February 24, 2022

Subject: REVISION 25 OF THE TRUPACT-II SHIPPING PACKAGE APPLICATION,
DOCKET NO. 71-9218, AND REVISION 8 OF THE HalfPACT SHIPPING
PACKAGE APPLICATION, DOCKET NO. 71-9279
(EPIDS L-2021-LLA-0033 AND L-2021-LLA-0034)

The responses to the questions submitted in Reference 6 are provided in Attachment A (Reference 7). New changes to the documents are summarized in Attachment B and are indicated by right-bars in the margin of the documents ("|"). Right-bars in the margin of the documents ("|") indicating technical changes made to the documents in the original submittal and the subsequent amendments of this application (References 2, 4, and 5) have also been retained with this submittal.

Figure 1 – SC-30G2 Gamma Scan Test Assembly Exploded View

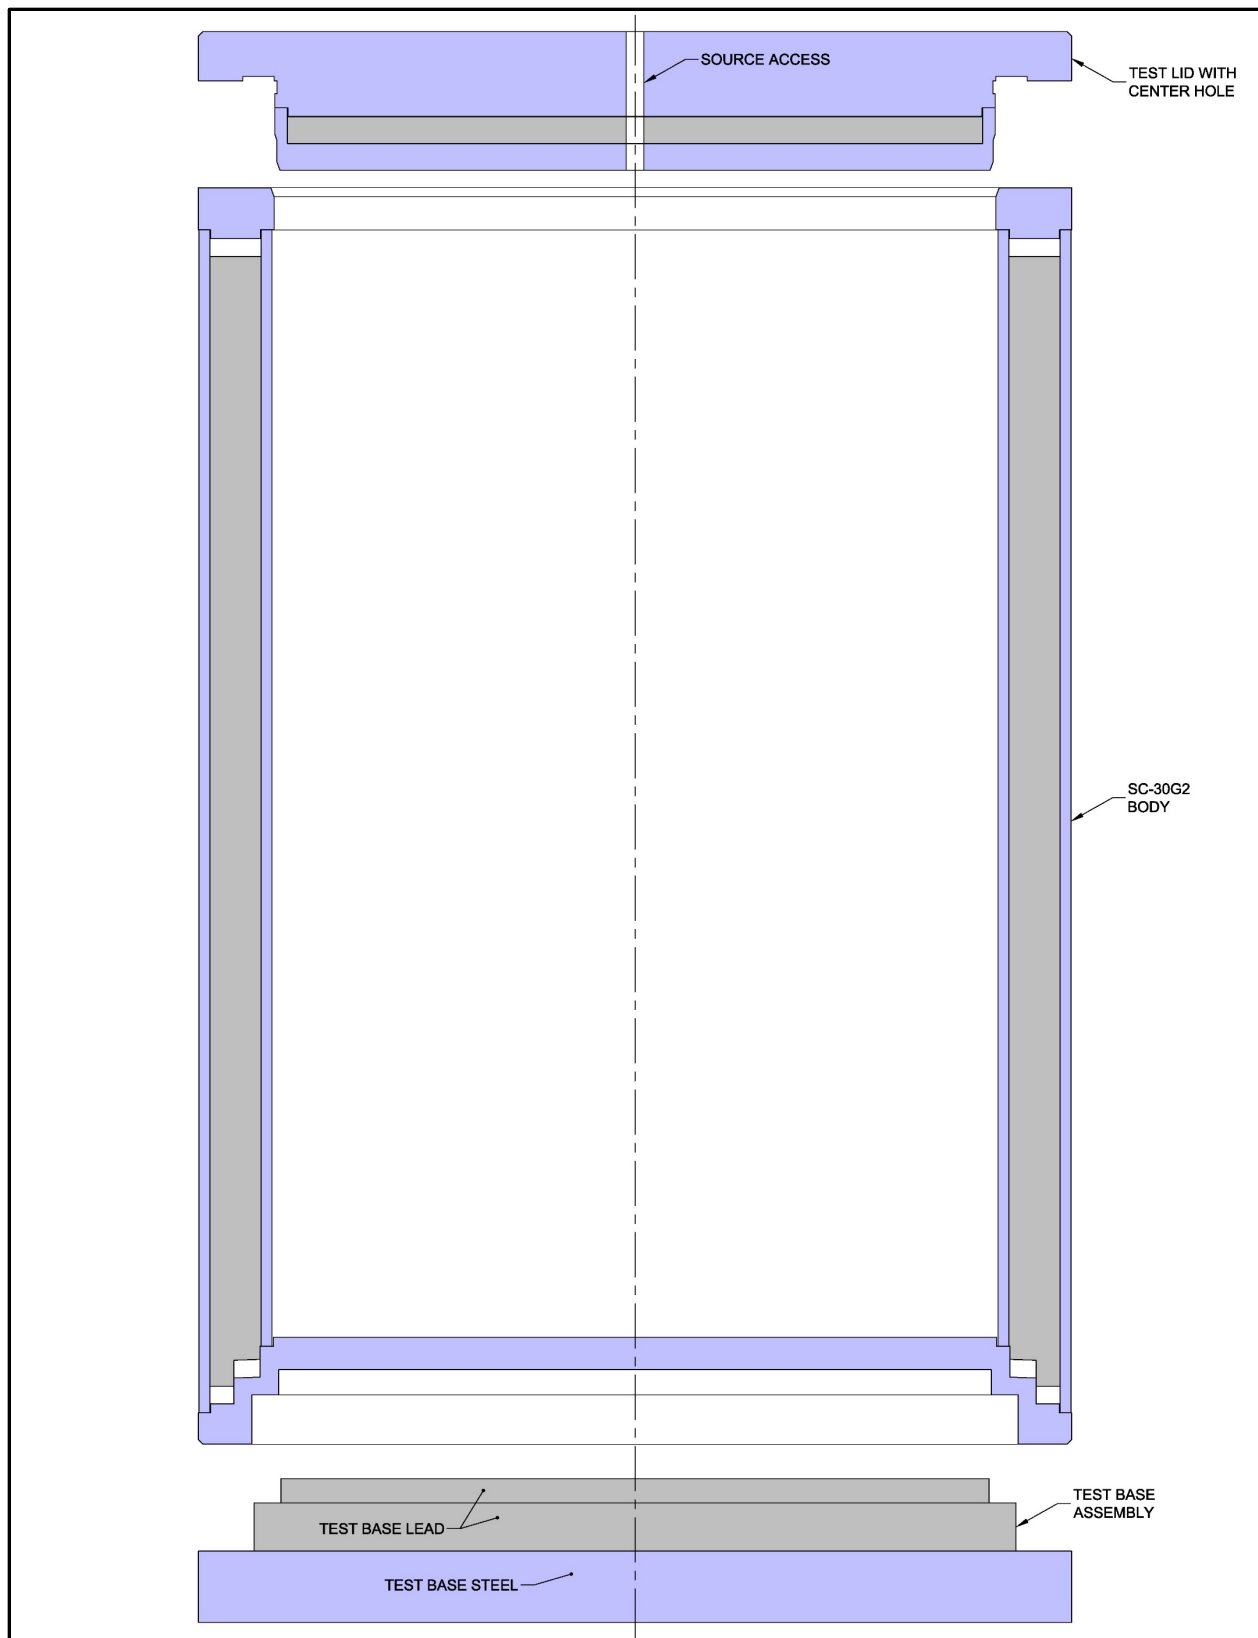
3. Is the gamma scan performed on an assembled container or only on individual components?

With reference to Figure 1, Figure 2, and Figure 3 for the SC-30G2, SC-30G3, and SC-55G2 shielded containers, respectively, the gamma scan process is performed on the container body without the base lead or outer base plates installed, and without the prototypic lid installed.

To simulate the presence of these components for ALARA purposes, a test base is used that has lead and steel plates of similar thicknesses and diameters as specified in the fabrication drawings, less sufficient sliding clearances to fit within the container body base for gamma scan testing. Similarly, the test lid is a prototypic lid, but also includes a center hole to allow access for the gamma scan test's radioactive source and a slightly reduced step diameter for sufficient clearance with the unfinished upper flange.

Upon successful completion of gamma scan testing, the base lead and steel plates are machined and installed in the body assembly and the filter shield plug and lid lead plate is machined and installed in the lid assembly.

Figure 4 – Example SC-30G3 Gamma Scan Test Configuration

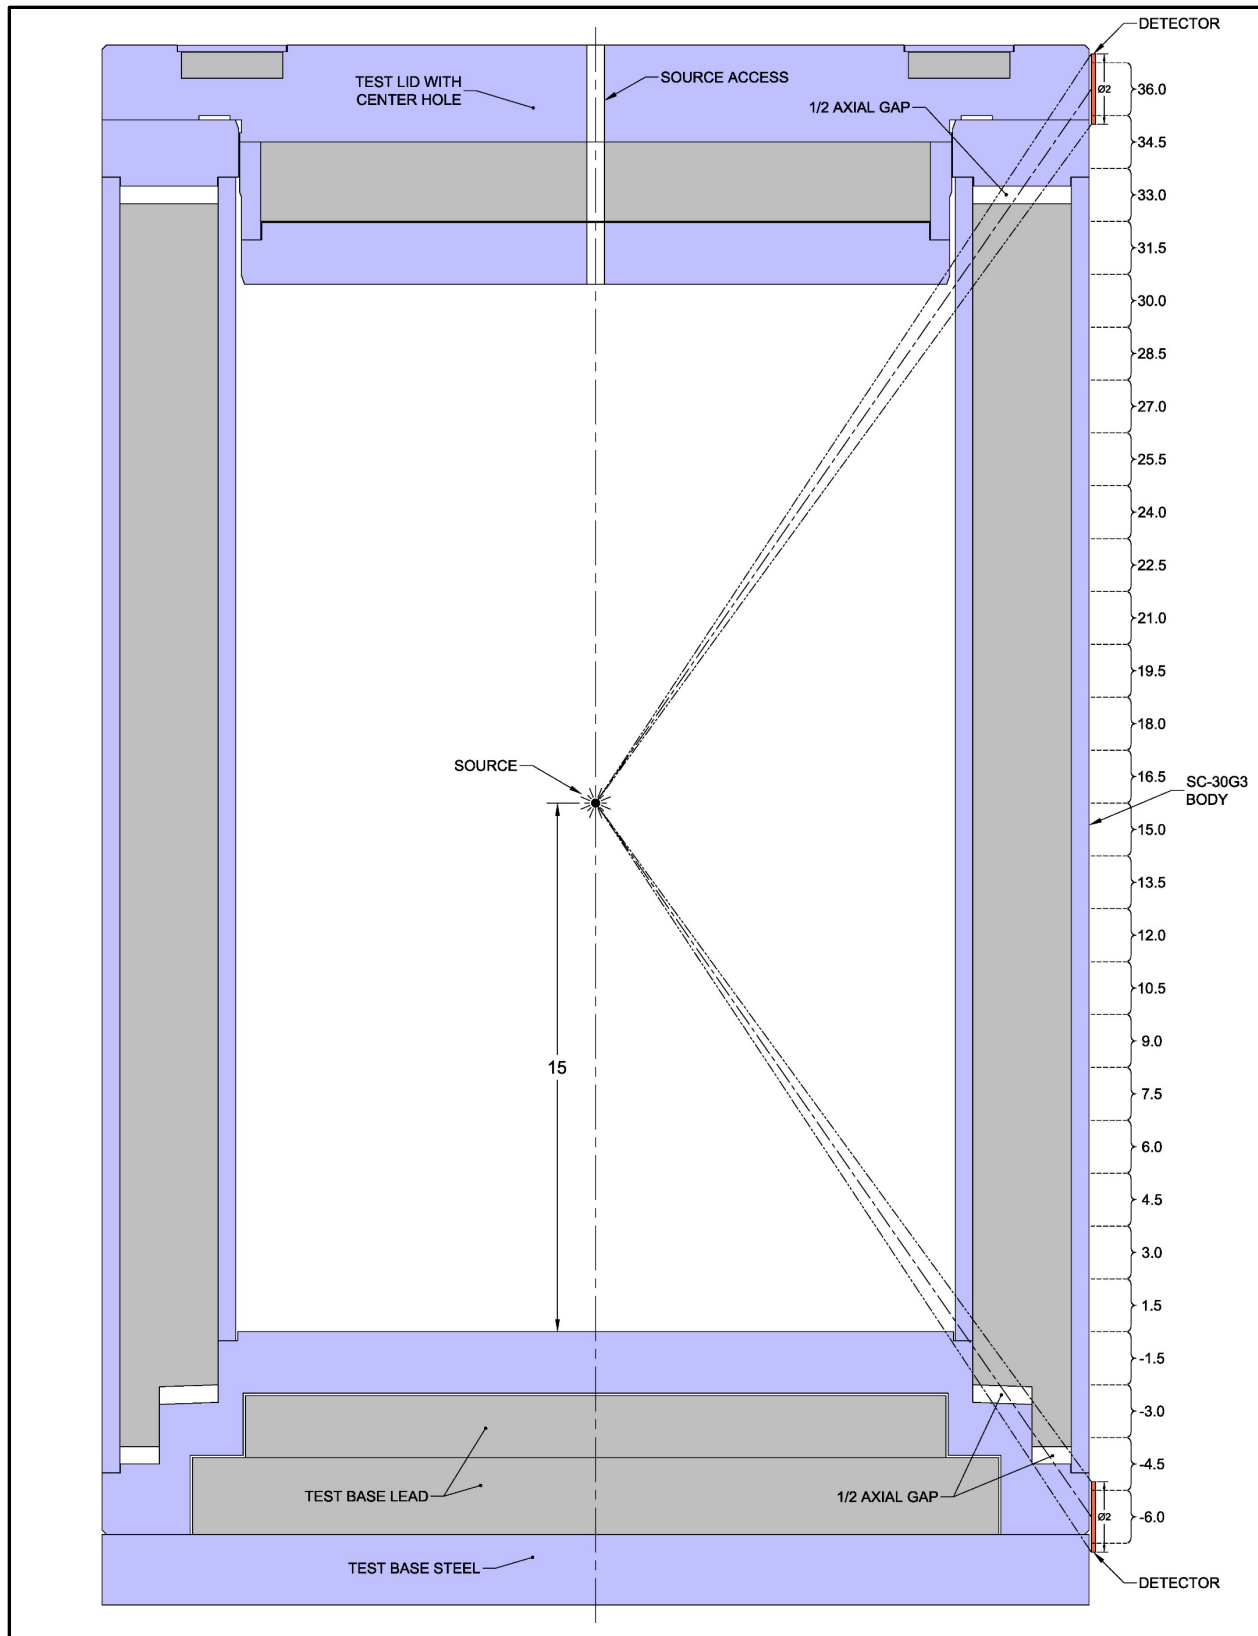
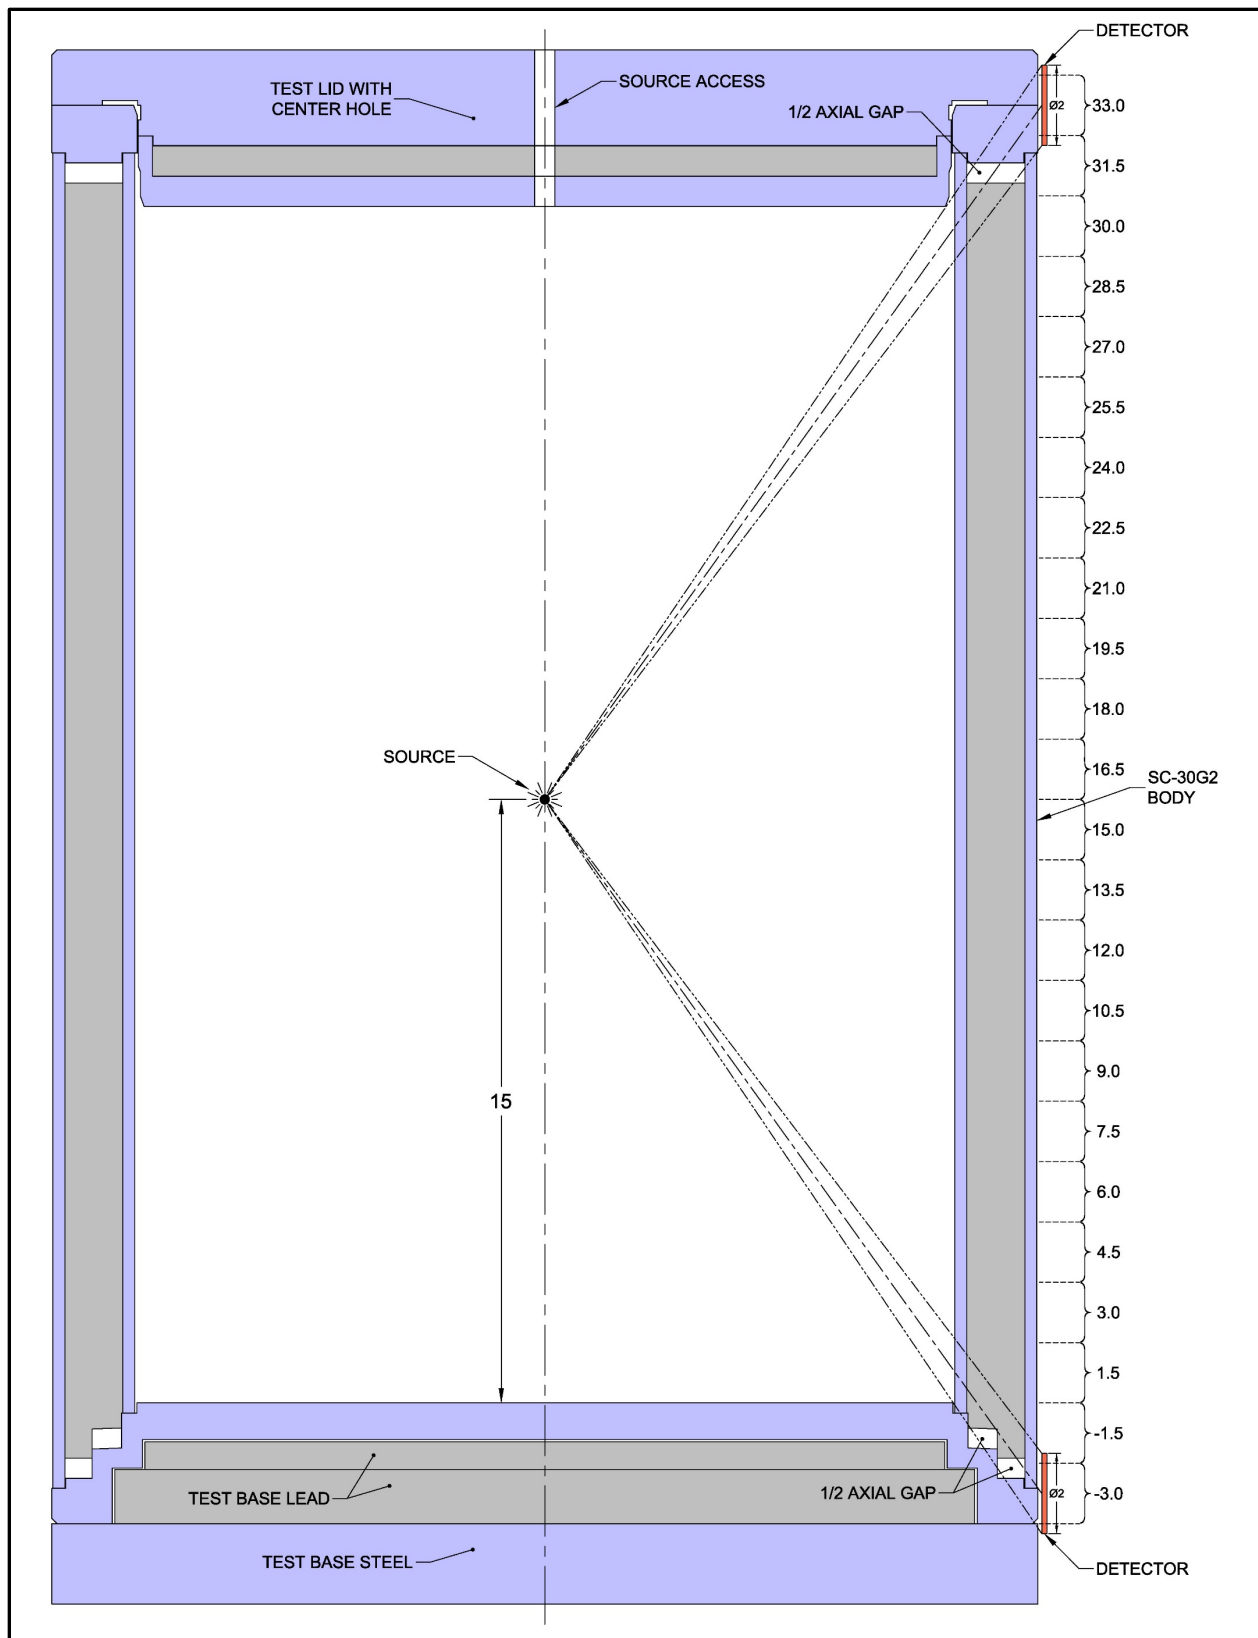
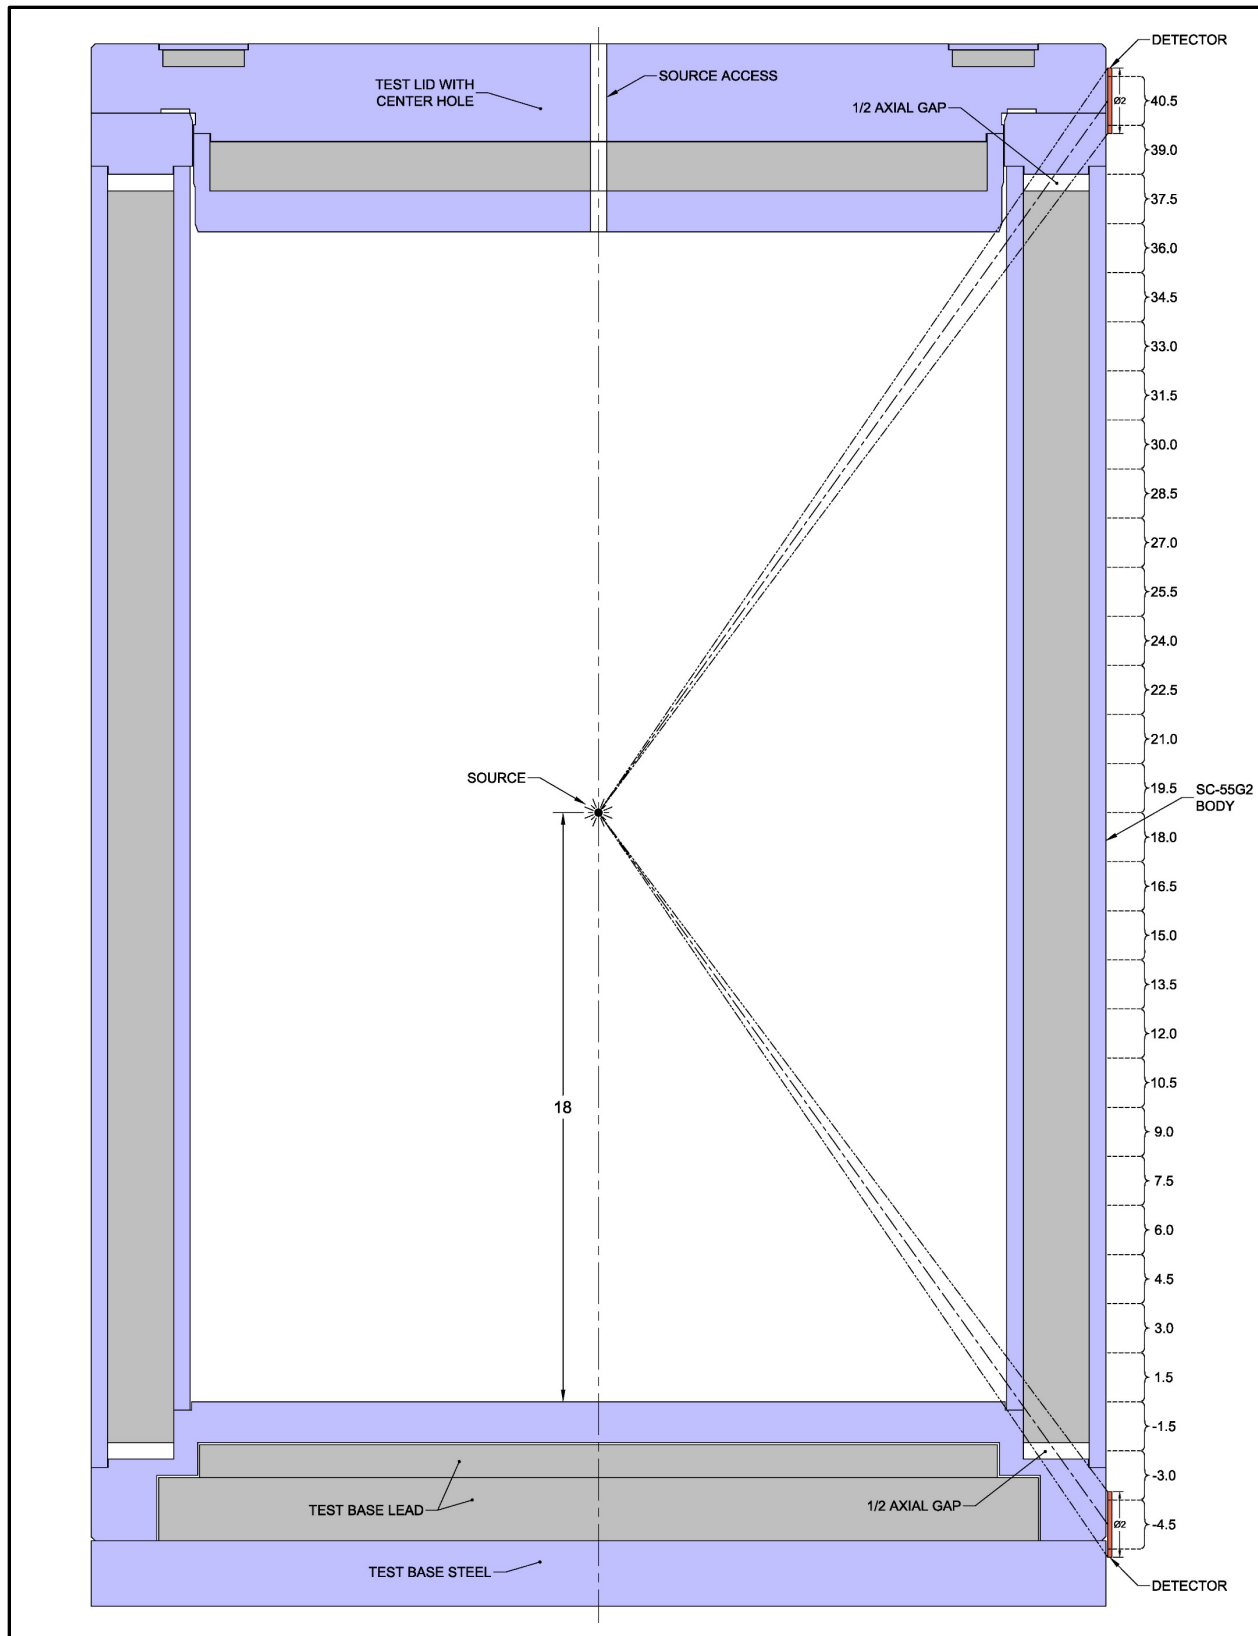
4. Explain how the gamma scan will be used to measure the thickness of the lead shield in the corners of the shielded container. If the gamma scan is not used, explain how you ensure that the thickness of the lead in the corners of the shielded container are within the values shown in the licensing drawings.

The current gamma scan process only evaluates shielding “efficacy” over the axial span of the payload cavity, a decision based on the deep overlap of the sidewall lead beyond the payload cavity preventing a significant increase in measured dose rate at the container’s surface. Shielding efficacy is determined by a combination of container geometry, materials, and distance between the source and detector.

With reference to Figure 4, grid locations aligned with the payload cavity are scanned with the source axially aligned with the detector; the reject count rate (RCR; i.e., acceptance criterion) is based on a flat-block calibration measurement. The axial grid locations for the straight-shot measurements are as follows: 1.5 – 30.0 for the SC-30G2 and SC-30G3, and 1.5 – 36.0 for the SC-55G2.

For axial grid locations below and above the payload cavity, however, the gamma scan procedure will be revised to include measurements for shielding efficacy using the following steps:

- a. Establish a source position above the bottom of the payload cavity that allows angled dose rate measurements beyond the payload cavity, including measuring for the presence of axial gaps in the sidewall lead. Figure 5, Figure 6, and Figure 7 for the SC-30G2, SC-30G3, and SC-55G2, respectively, show the detector in its lowest and highest grid positions for detecting the presence of axial gaps at the ends of the sidewall lead column. The detector in the three figures is assumed to have a relatively standard, 2-inch diameter scintillator face.

- b. Create MCNP models of the prototypic gamma scan test configurations for the SC-30G2, SC-30G3, and SC-55G2 designs with minimum material conditions, i.e., minimum steel shell and sidewall lead thicknesses, including the presence of a 1/2-inch axial gap at both ends of the sidewall lead column. The model will include a test base and lid, as described in the previous response; both are reusable for gamma scan testing all units of that size.

- c. Run the three MCNP models for a unit source strength of ^{60}Co and ^{192}Ir (the two most commonly used radionuclides for gamma scan testing) for a straight-through-the-wall baseline case, then for the “slant-shot” grid rows below and above the payload cavity. For example, with reference to Figure 5 for the SC-30G2, the below and above grid locations are -1.5, -3.0, 31.5, and 33.0. An RCR adjustment factor can be applied to these slant-shot grid rows by calculating the ratio of the slant-shot unit dose rate with the straight-through unit dose rate for each grid row.
